TOWN OF ERIE POLICE DEPARTMENT ADDITION & RENOVATION

SITE PLAN

TOWN OF ERIE
ERIE PD - ADDITION & RENOVATION
1000 TELLEEN AVENUE, ERIE, COLORADO 80516
COVER SHEET

SHEET IDENTIFICATION
C-101

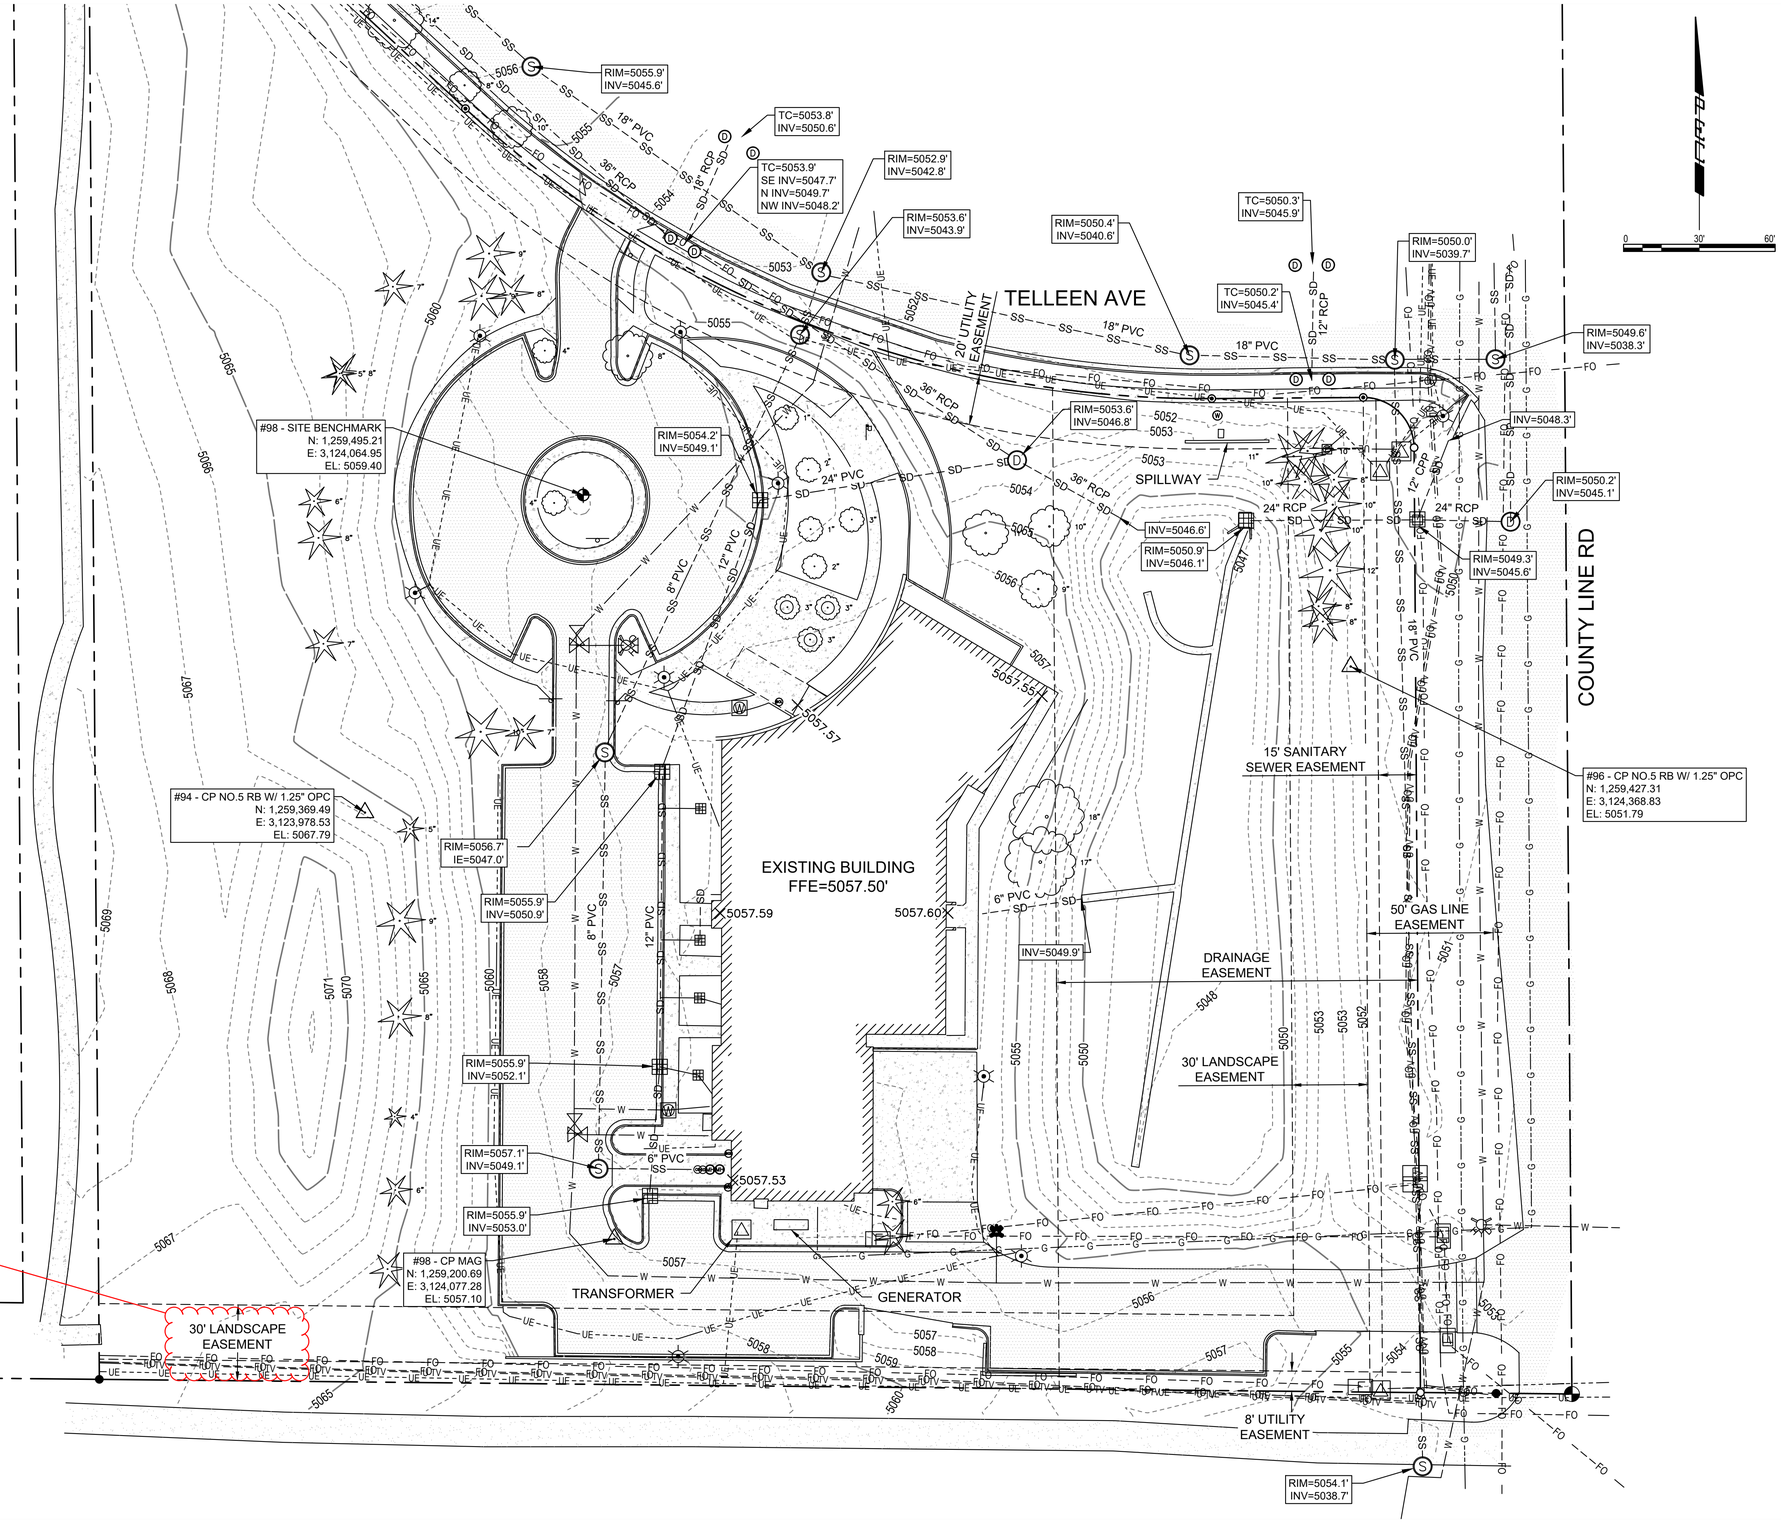
6. The original pond design provided a forebay at the north existing storm sewer outfall. Confirm that this feature still exists and label on Sheet C-101 Existing Conditions. Also, provide a forebay for the new south storm sewer outfall.

a. Existing forebay labeled on Sheet C-101 Existing Conditions. Existing forebay is an earthen forebay with heavy vegetation to collect sediment and provide energy dissipation. Proposed storm sewer outfall into southern end of existing detention pond is a concrete forebay with baffle wall for energy dissipation and riprap boundary for overtopping flows.

SHEET IDENTIFICATION
C-201

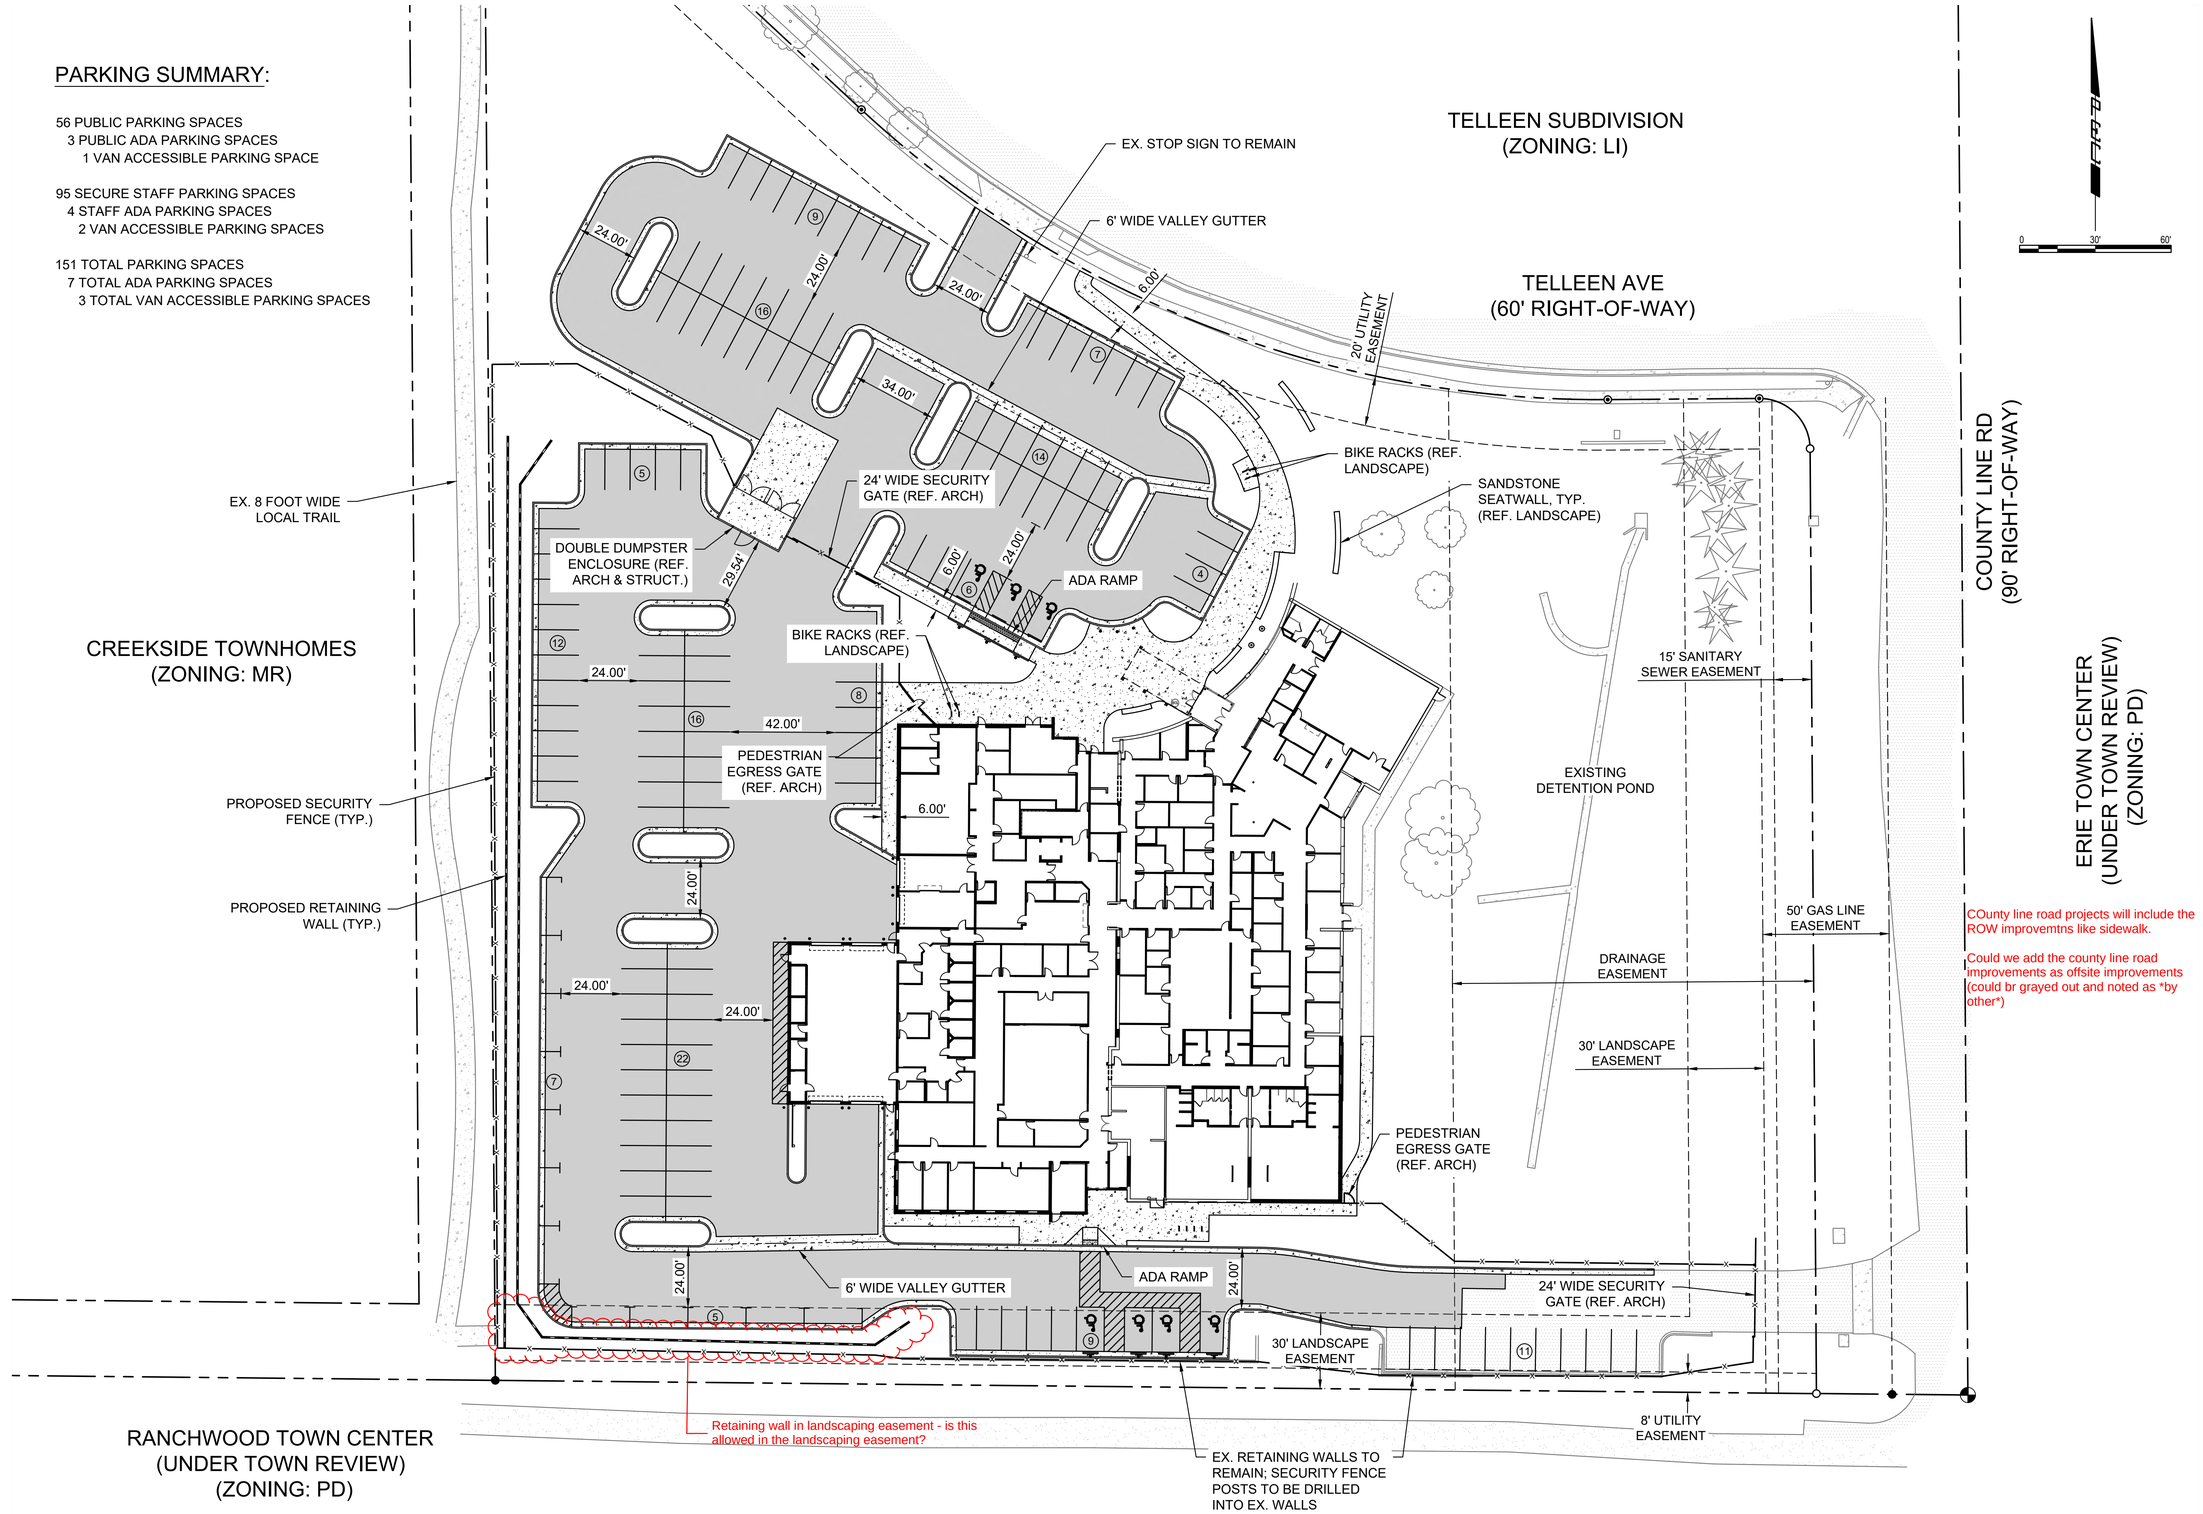
COunty line road projects will include the ROW improvemtns like sidewalk.

Could we add the county line road improvements as offsite improvements (could br grayed out and noted as *by other*)

SHEET IDENTIFICATION
C-304

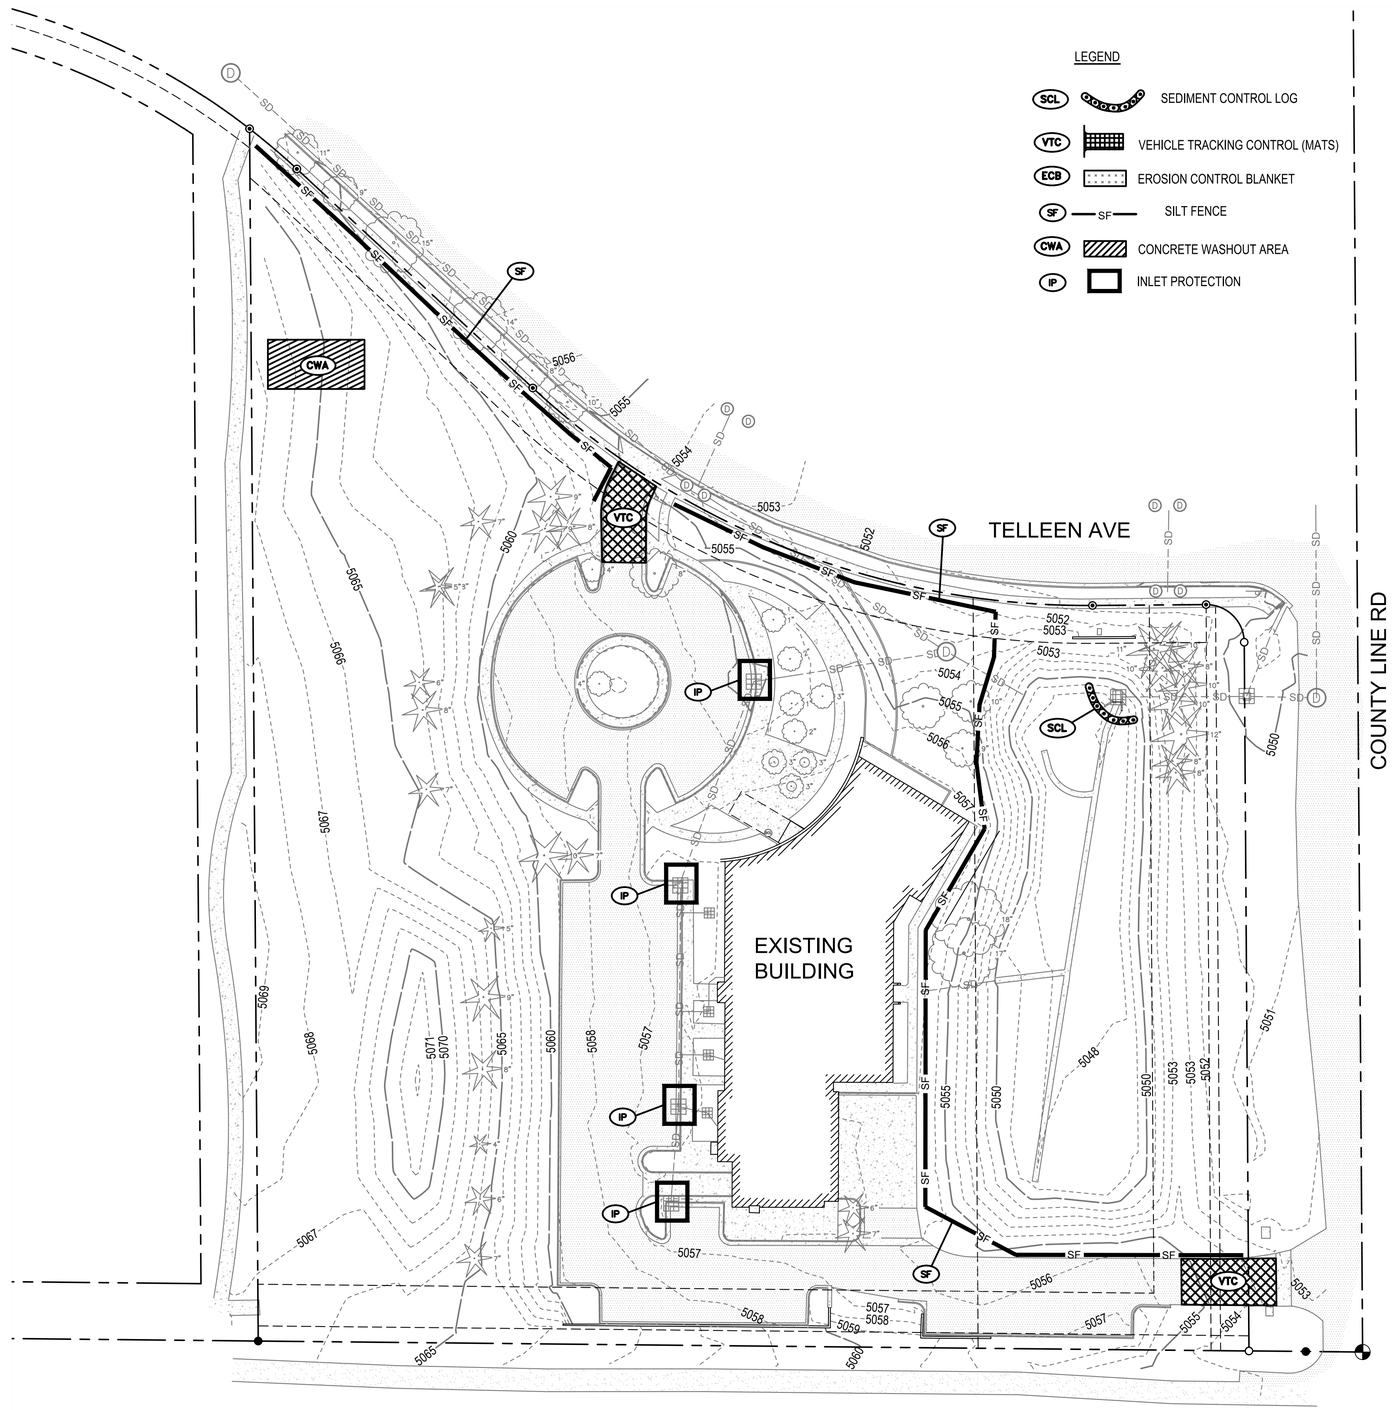
1. General comments- please identify seed mix for the detention pond. There will be disturbances that will require restoration.
2. Sheet C-304- Identify IP and VTC as initial control measures.

8. On Sheet C-304, use alternative inlet protection for the pond outlet structure since a sediment control log cannot be properly anchored with the concrete trickle channel. Possibly use a rock sock that is heavier.
